UNITED STATES PATENT AND TRADEMARK OFFICE

10/585,387

Office Action Summary	Application No. 10/585,387	Applicant(s) JIANZHENG, BIAN	
	Examiner MICHAEL P. FERGUSON	Art Unit 3679

DETAILED ACTION

a lock shell **1** having inclined bearing surfaces **a,a'** (Figure 1 reprinted below with annotations) in a front portion thereon;

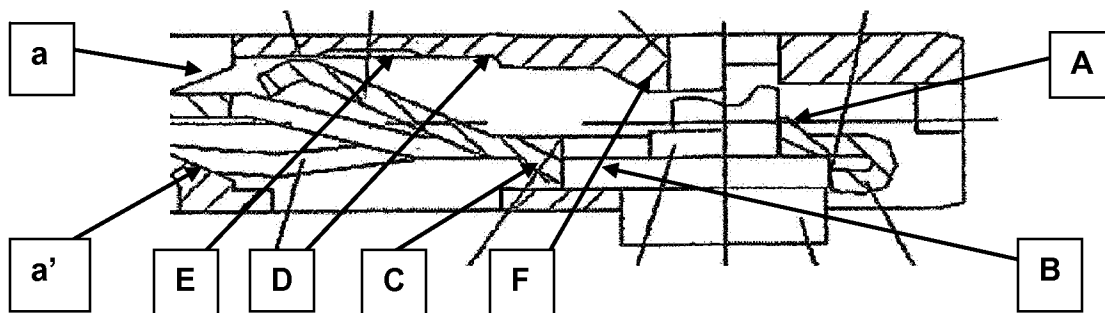
As to claim 9, Applicant's admitted prior art (Figures 1-3) discloses a connecting lock for exhibition stands, the connecting lock comprising:

a lock plate **2** having a front end and a back end, a plurality of plate tongues **1010,1011,1012** being disposed at the front end of the lock plate, an end of each plate tongue being bent into a hook **21,22,23** with a reverse bending direction between adjacent hooks and each plate tongue having a beveled surface, the plate tongues being separated by a plurality of elongated slots **1001,1002**, each slot being divided into three sections **41,42,43** of different widths;

a stop tooth **A** disposed on the lock plate (tooth **A** engages cam surface **362** to limit [stop] rotation of lock cam **3**; thus constituting a stop tooth; Figure 1); and

an eccentric lock cam **3**, having an eccentric cam **B**, the lock plate being inserted into the lock shell, and the eccentric lock cam being inserted through a first hole and a

second hole **5**, and into a third hole **53**, wherein the first hole has an arc and the first hole and the third hole are formed in the lock shell, and the second hole is formed in the lock plate,

wherein the eccentric cam on the eccentric lock cam and the stop tooth on the lock plate constitute a stop structure, wherein when the eccentric lock cam is rotated within the first, second and third holes, the eccentric cam engages the stop tooth, thereby limiting rotation of the eccentric lock cam and movement of the lock plate relative to the lock shell (Figures 1-3).

As to claim 10, Applicant's admitted prior art (Figure 1) discloses a connecting lock comprising a barrier tooth **C** on the lock plate **2** (tooth **C** forms a barrier of hole **5**; thus constituting a barrier tooth; Figures 1 and 3).

As to claim 11, Applicant's admitted prior art (Figure 1) discloses a connecting lock wherein a first rectangular hole **D** is formed on an upper surface of the lock shell **1**.

As to claim 12, Applicant's admitted prior art (Figure 1) discloses a connecting lock wherein a second rectangular hole **E** is formed on an upper side of the lock shell **1**.

As to claim 13, Applicant's admitted prior art (Figure 1) discloses a connecting lock comprising a flange strip **F** disposed on an internal surface of a bottom side of the lock shell **1**.

As to claim 15, Applicant's admitted prior art (Figure 1) discloses a connecting lock wherein the back end of the lock plate **2** is bent into a U-shaped half-loop **26** having an end surface that is a planar.

As to claim 16, Applicant's admitted prior art (Figure 1) discloses a connecting lock comprising a wedged bulge **C,26** disposed on the lock plate **2** (bulges **C,26** wedge against eccentric cam **B**; thus constituting a wedged bulge; Figure 1).
